Attention **Merle Keefe, Environmental Permitting Manager for Sabina Gold and Silver**
Subject **Goose Project Site – 2021 Annual Geotechnical Inspection**
Project 1CS020.021

The 2021 AGI for the Goose site is the subject of this memorandum.

Back River Project

2021 Annual Inspection

DRAWING TITLE: General Arrangement
Comparison of 2021 Infrastructure to
Final Development Plans

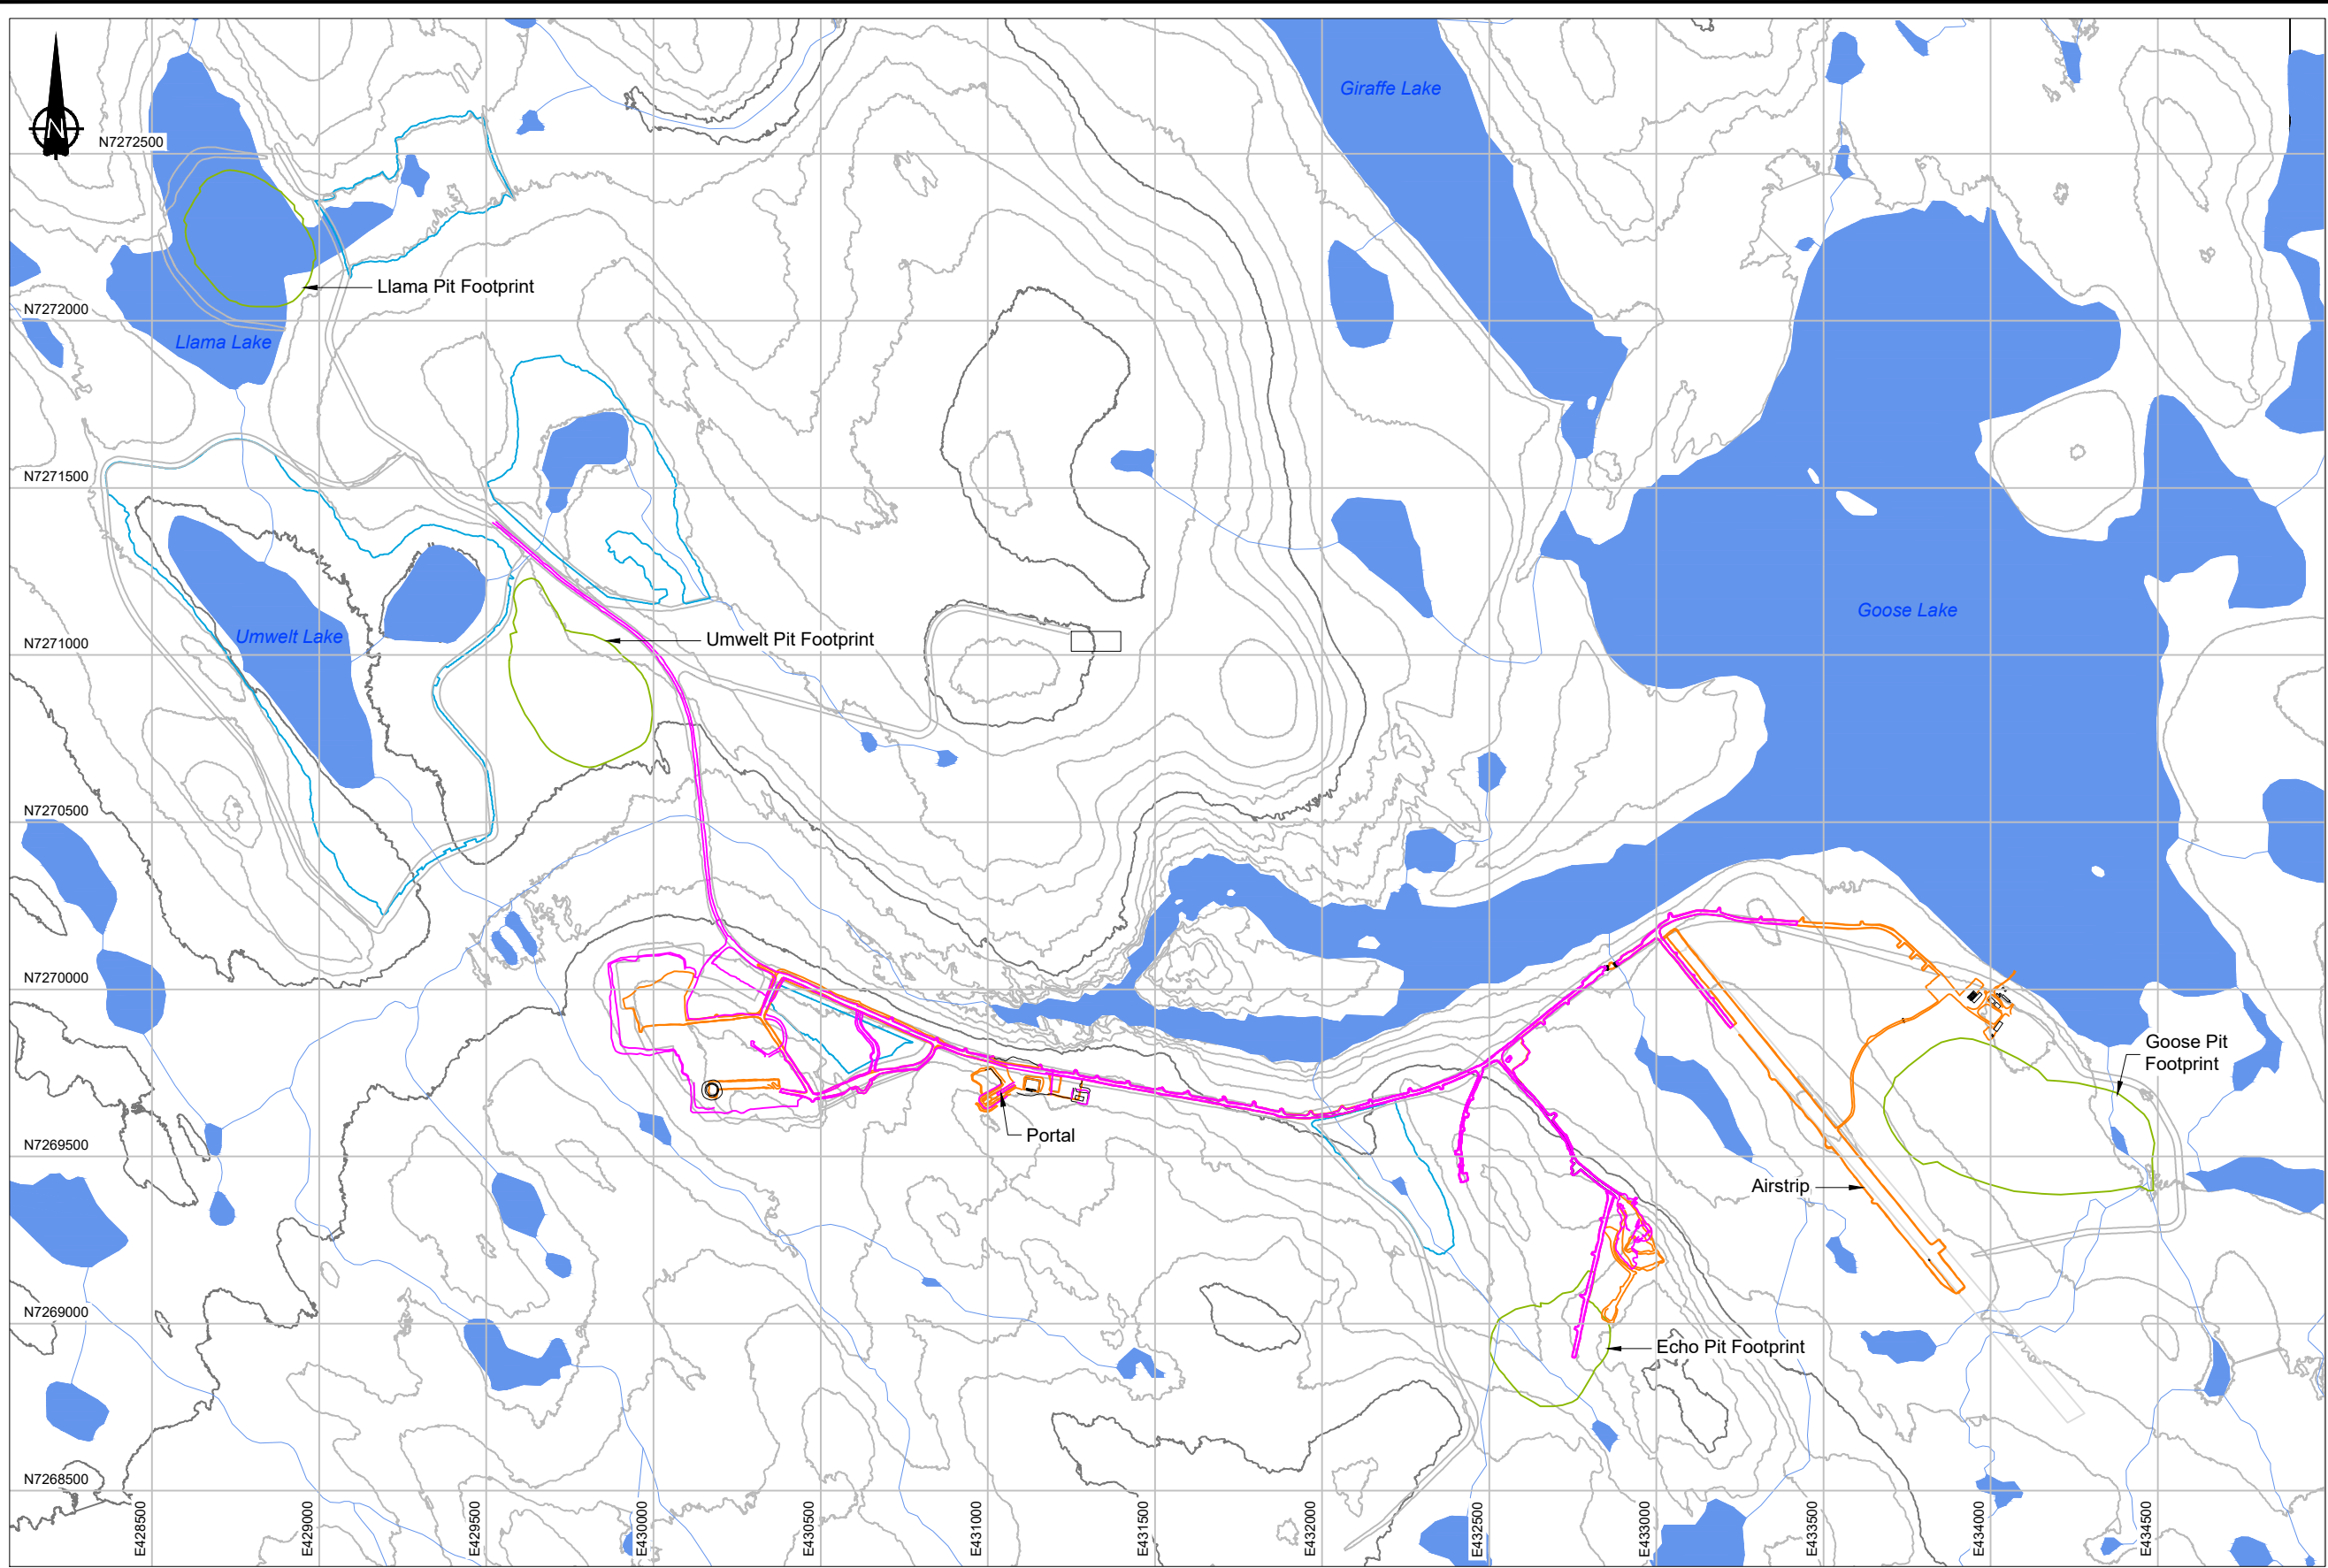
Notwithstanding the observations and recommendations provided in this AGI (see Attachment 1), the Back River site is performing in reasonable accordance with predicted geotechnical expectations. The main observation as part of the 2021 AGI was that, as the site is currently in a transition stage and that many of the pads and roads and water conveyance (culvert) structures were at an interim state. Figure 1 shows recent earthwork progress at the Goose site, in comparison to the final design footprints, and highlights some of the current in progress areas that Saina is working on as Goose moves from exploration towards a development and operational stage.

Specifically, many of the areas of the roads, and area along the southwestern side of the Goose Airstrip expansion had fill thicknesses less than the final design thickness. If these areas are left in an underbuilt stage for multiple years, then the active layer in these areas would be expected to deepen, and either require more long-term maintenance (until conditions stabilize), or additional fill thicknesses (to accommodate a deepening active layer).

From a performance and geotechnical point, a closer review of what has been installed at the Echo Creek crossing, and the temporary measures at the Goose Neck crossing is suggested. Some tension cracking was seen near the shoulders of the road adjacent to, and that will ultimately become part of, the future Camp Pad Pond. Sabina should consider near term widening and/or additional fill placement (increased thickness) at that camp pad pond road section. From a safety point of view, close monitoring of the Goose Airstrip remains a top priority. Additional comments and observations are provided in the attached Figure and Attachments 1 to 3.

Future Site Layout – Plan Overview

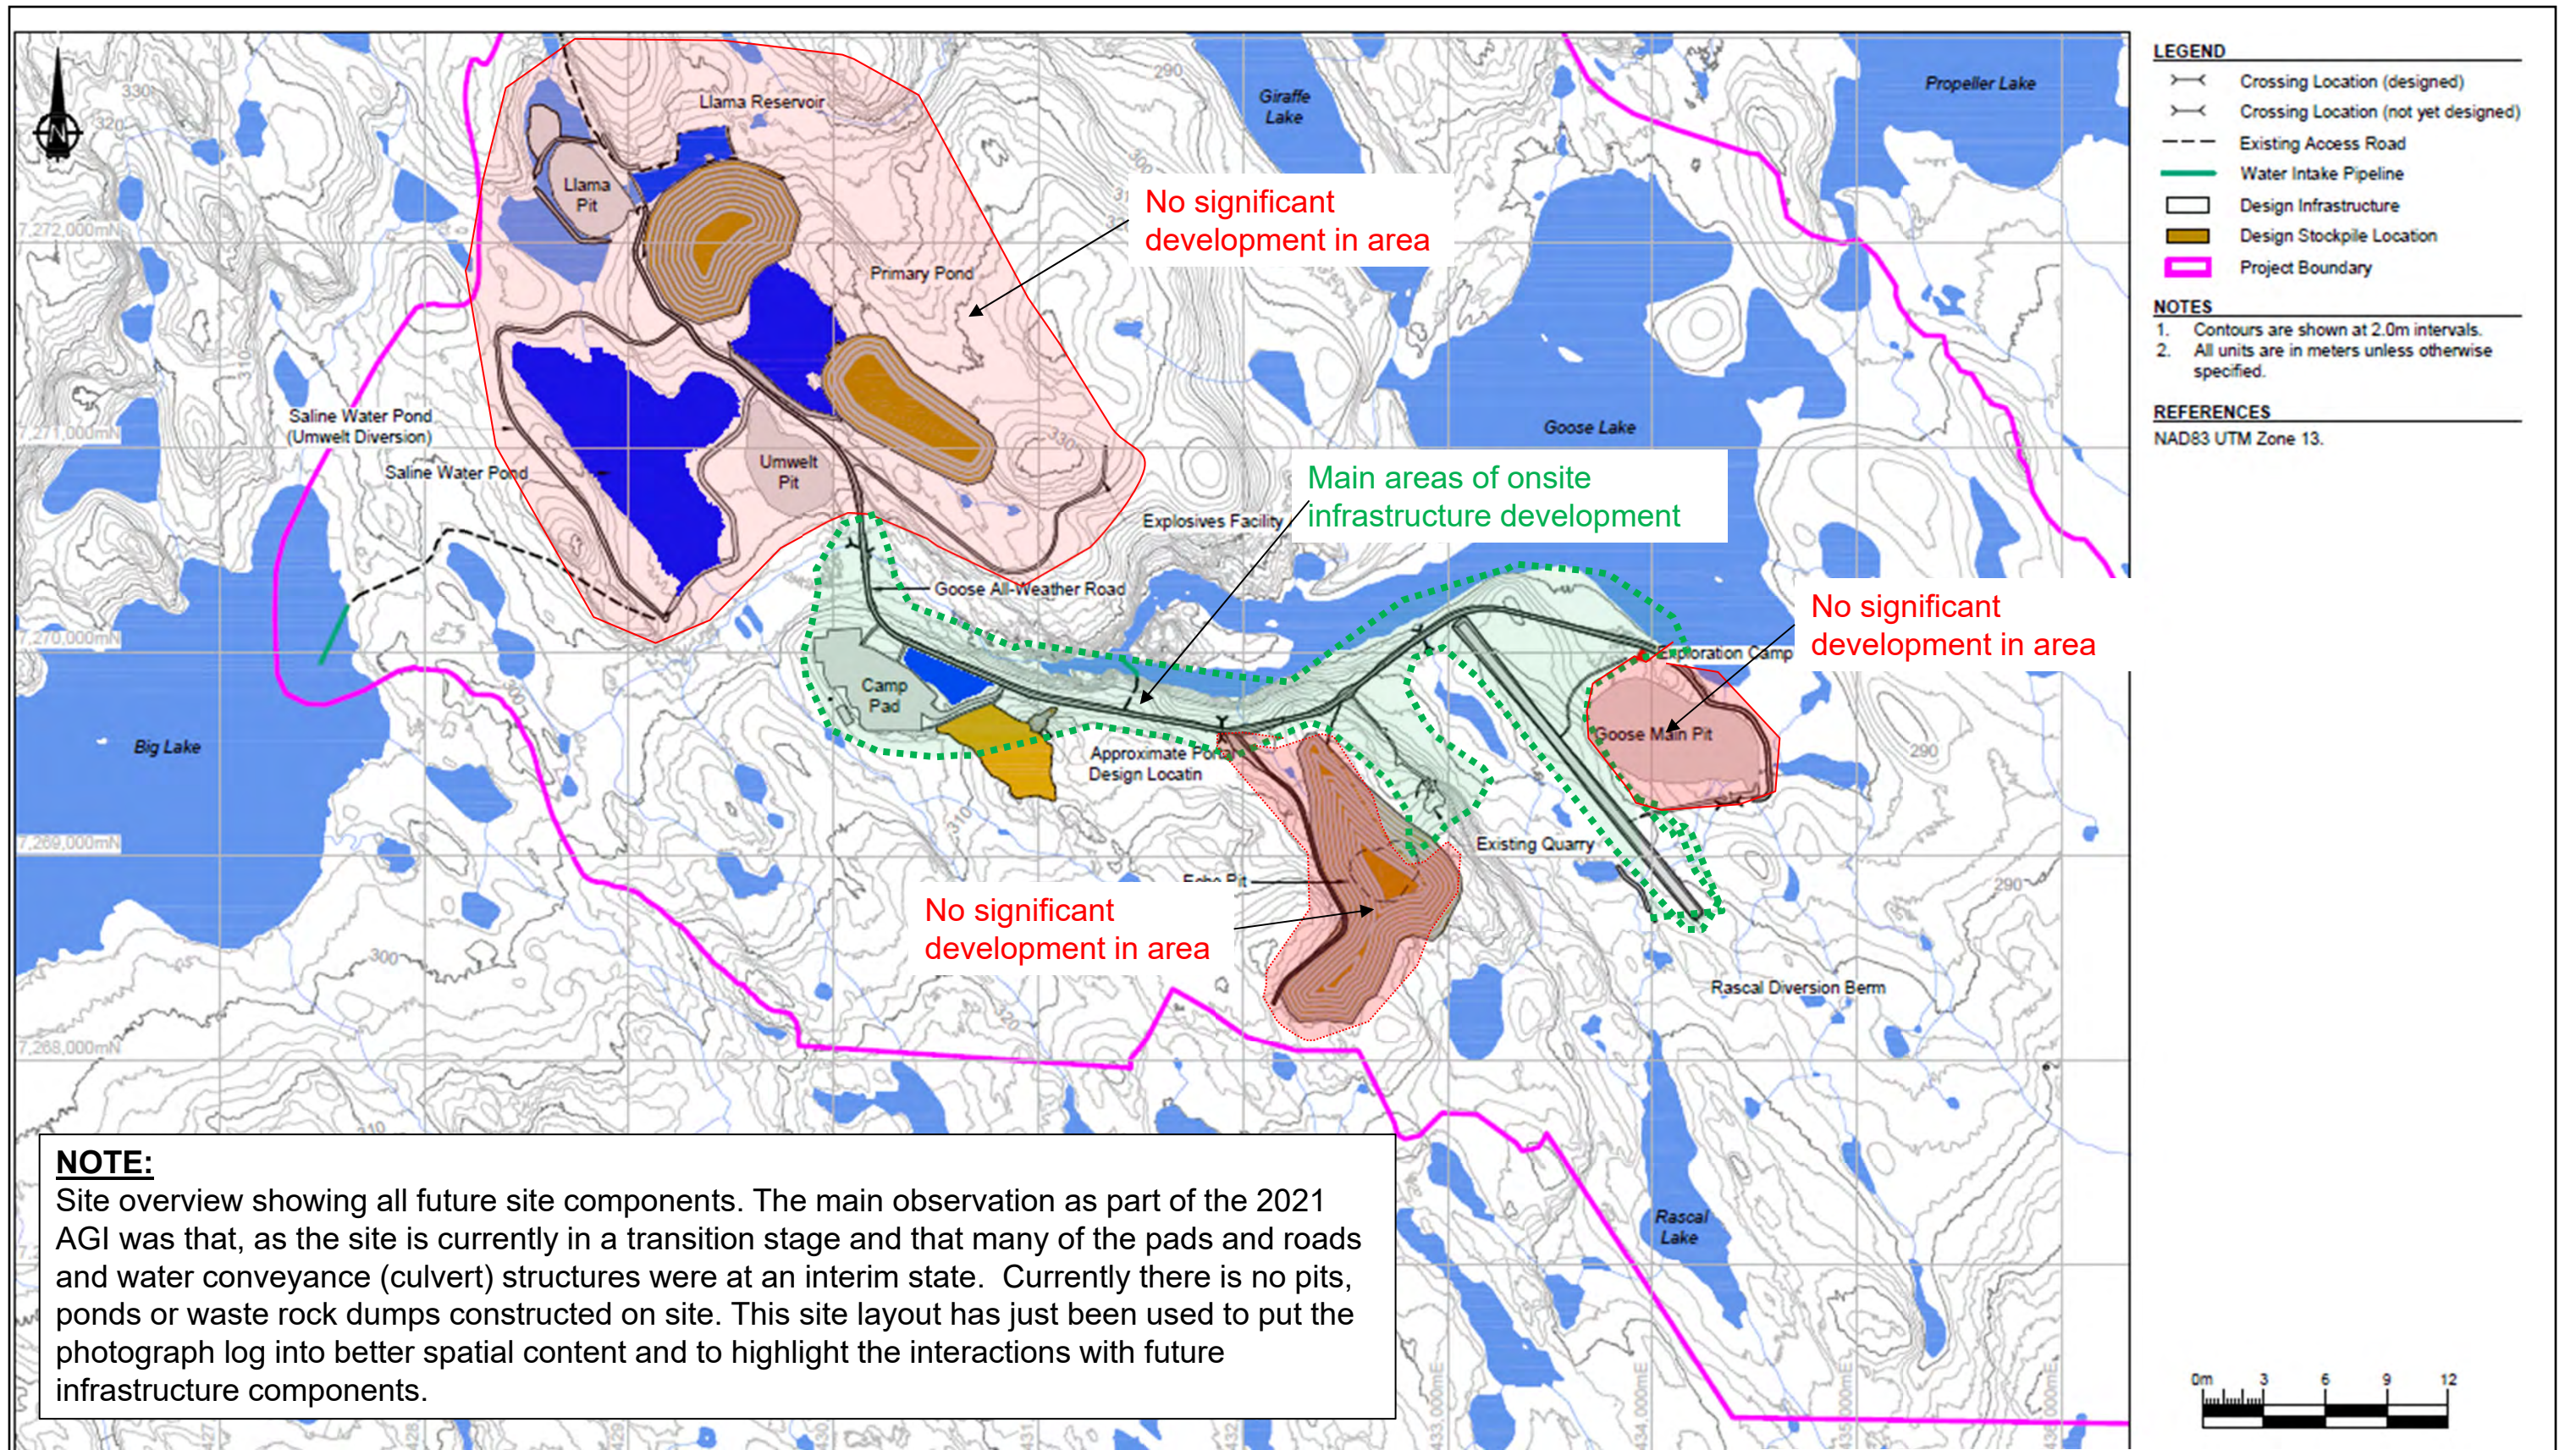
Site overview showing all future site components. The main observation as part of the 2021 AGI was that, as the site is currently in a transition stage and that many of the pads and roads and water conveyance (culvert) structures were at an interim state. Currently there is no pits, ponds or waste rock dumps constructed on site. This site layout has just been used to put the photograph log into better spatial content and to highlight the interactions with future infrastructure components.
